AP600 DESIGN CHANGE DESCRIPTION REPORT

February 15, 1994

Westinghouse Electric Corporation

FIGURE 2-3 PRHR HX INLET ISOLATION

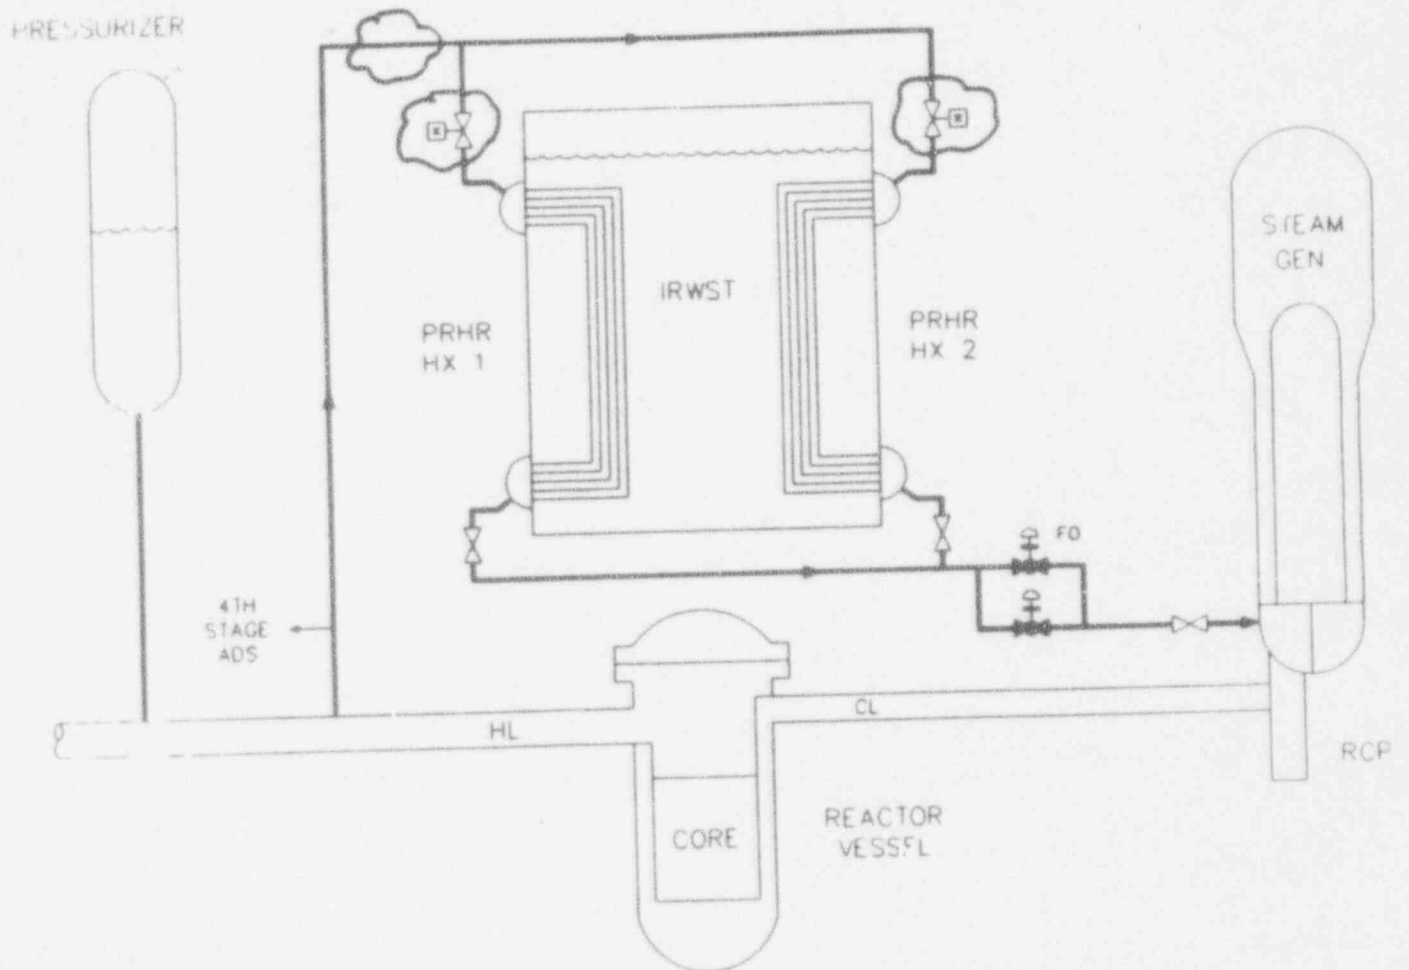
A motor-operated valve (MOV) is added in the inlet line to each PRHR HX. Two MOVs replace the two manual valves and a MOV in the common line. Figure 2-4 shows this arrangement.
